# **SERVICE INFORMATION NO. SI40-008**

Vision Microsystems Engine Indication

# **Vision Microsystems Product Service Bulletin**

PSB Number: 02 04 30 09

#### **APPENDIX A: Corrective action procedures.**

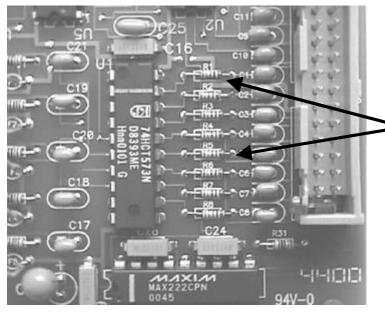
<u>Purpose:</u> Occasionally, ONLY during 'power-up', the VM1000 would go into a 'test' display. Re-cycling power would initiate normal operation.

<u>Applicability</u>: VM1000 systems using software programs numbered 3034001 or higher with assembly 3020018 (Rev B or below) and fuel level probes connected to the left and right fuel probe inputs.

- STEP 1. Remove assembly 3020018 from the aircraft and place on a clean static protected workbench.
- STEP 2. Remove Resistors R1, R2, R3, R4, & R5. Using miniature diagonal 'side cutters', clip the leads at each end of the resistor and discard the parts. The remaining lead fragments attached to the PC board should be carefully clipped off near the board surface or removed by simply bending the lead back and forth until they break away at the board surface. INSURE THAT YOU REMOVE ALL FRAGMENTS, but do **not** use compressed air due to contaminants and static electricity.

- STEP 3. Mark the Identification tag. For assembly 3020018 Rev \_ & Rev A, mark the Identification Tag MOD 1 next to the Rev letter. For assembly 3020018 Rev B, mark out the Rev B on the Identification Tag and change it to Rev C.
